# Memorandum

**RE:** **TSG Chesterfield Airport Road, Lot A (Jaguar Land Rover):** A Site Development Section Plan, Landscape Plan, Mitigation Plan, Lighting Plan, Architectural Elevations and Architect's Statement of Design for an 8.728 acre tract of land zoned "PC" Planned Commercial District located north of Chesterfield Airport Road and east of Long Road. (Ward 4).

Re: TSG Chesterfield Airport Road, Lot 1 SDSP (Jaguar Land Rover) – Response Letter  
(Stock Project No. (218-6407.4)

SOUTH ELEVATION

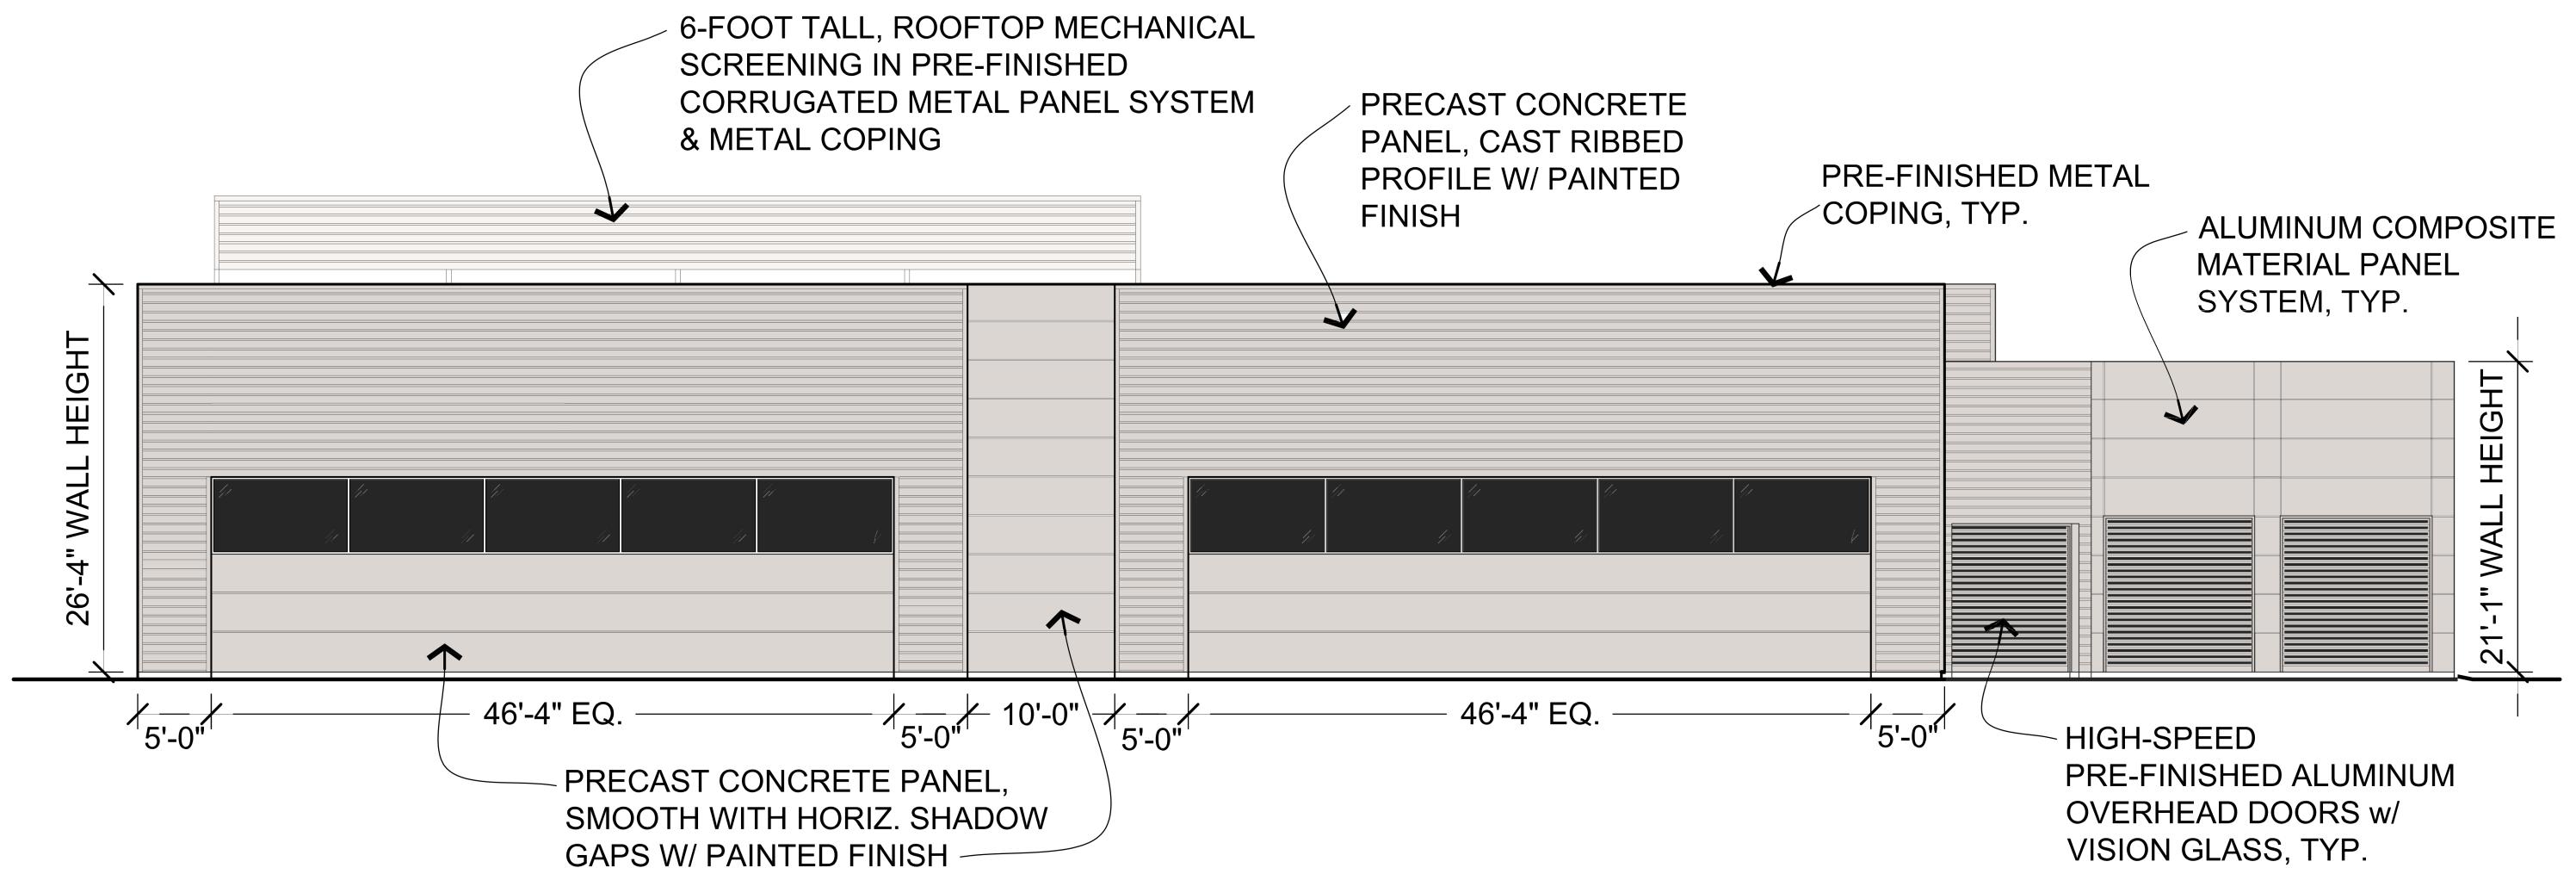
2. The South elevation depicts two triangles that are not called out on the elevations. For reference, see the image below. Revise the elevation as necessary to include a call out for this item.

Response: The triangles referenced and as seen on the South Elevation are pyramidal skylights above the service department. The Owner has opted to remove these skylights since there have been windows added to the South Elevation. This change is reflected within the enclosed submittal.

WEST ELEVATION

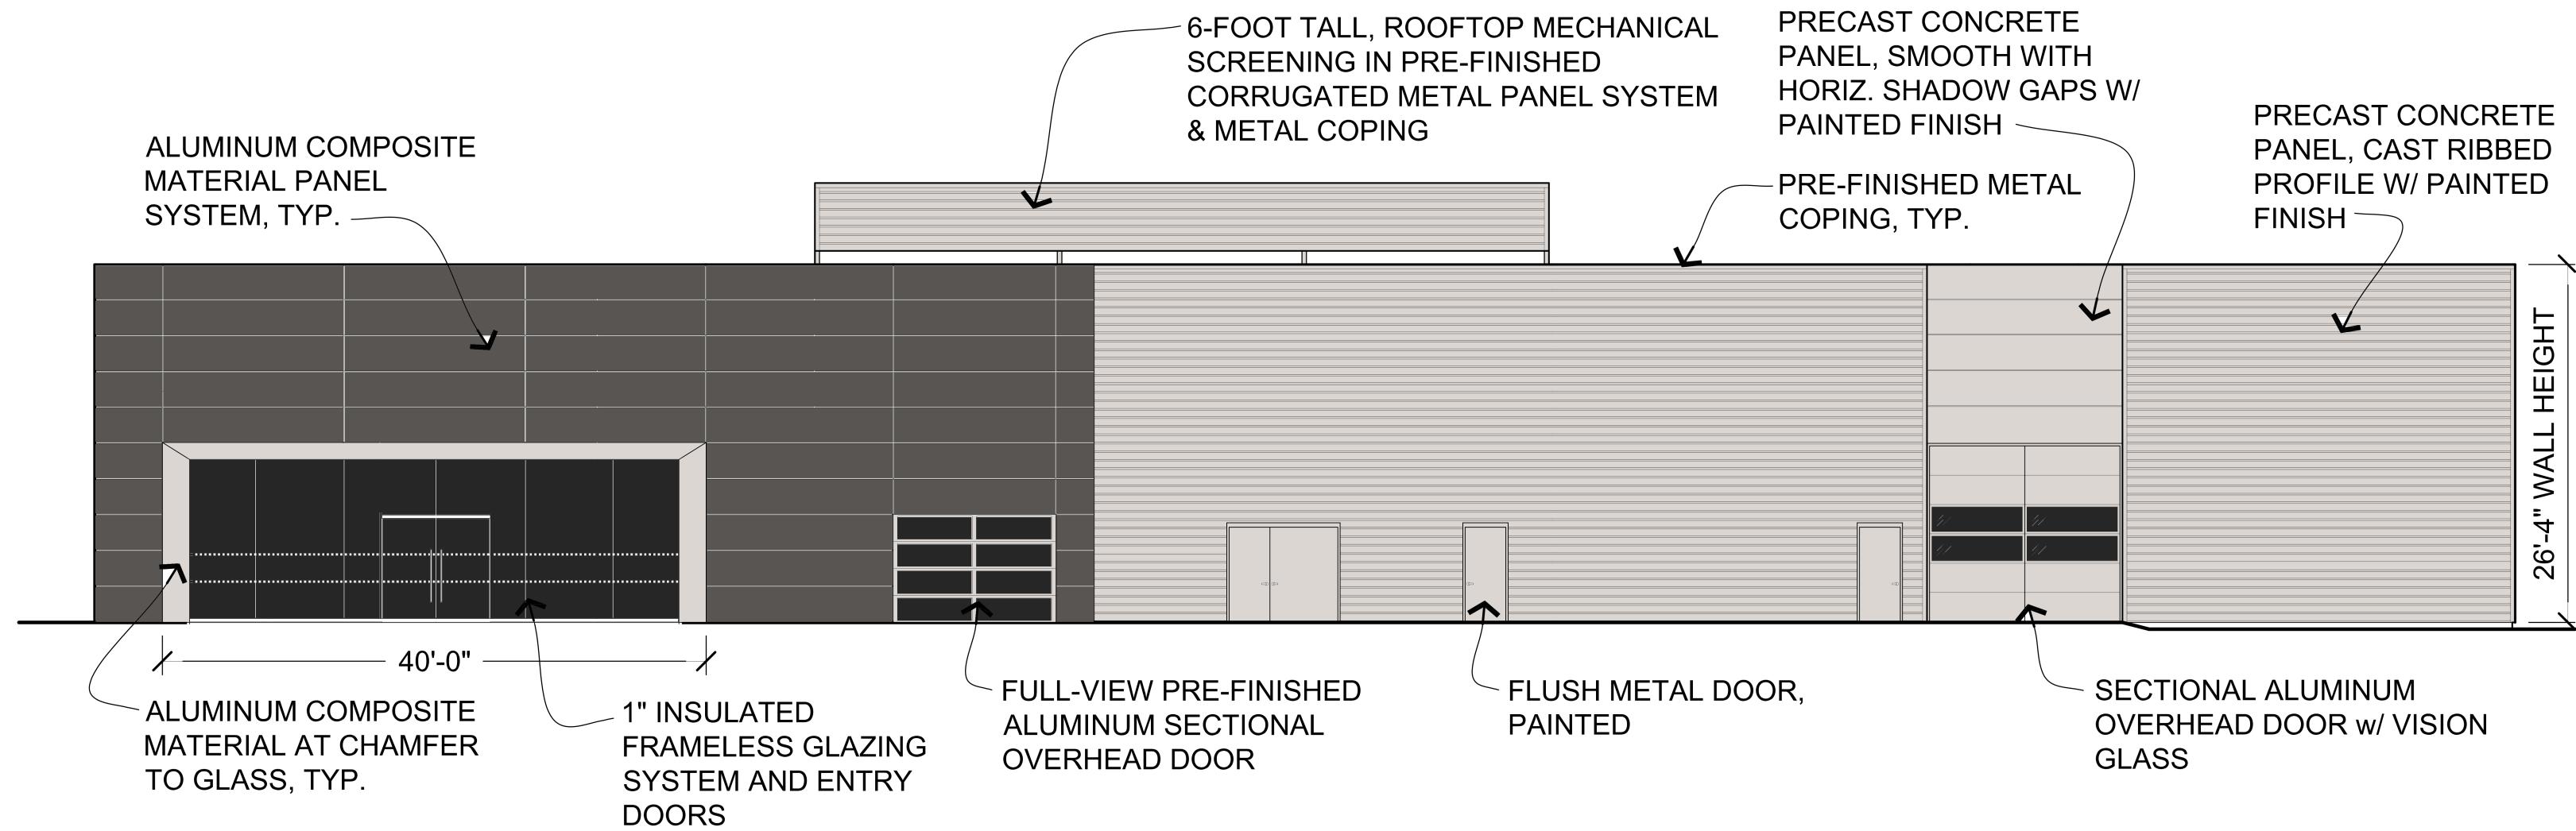
1. The Architectural Review Board recommended approval with conditions on March 12th, 2020. The recommendations were as follows:
  - To further enhance the concept of a four-sided building that has equal attractiveness of architectural elements on the front façade (show room) with the sides and rear (service area).
  - Introduce a higher quality material, possibly the concrete tilt up panel vs. the corrugated metal as a primary material

In order to meet the Architectural Review Board's recommendation, revise the west elevation as necessary to create a more uniform and integrated elevation.

**Response:** The west elevation has gone through two changes since the last submittal. The first is a change to the exterior materials. The areas previously clad in corrugated metal panels have been revised to architectural precast concrete. The corrugated metal panels have been eliminated from the facades of all sides of the building and only remain at the rooftop mechanical screen walls. The second change is revising the architectural precast panels above the service door to a smooth finish painted to match the aluminum composite panels that are above the Front Entry on the North elevation. These changes have been negotiated and approved via Jaguar Land Rover corporate procedures. Additional changes will most likely not be approved by Jaguar Land Rover.
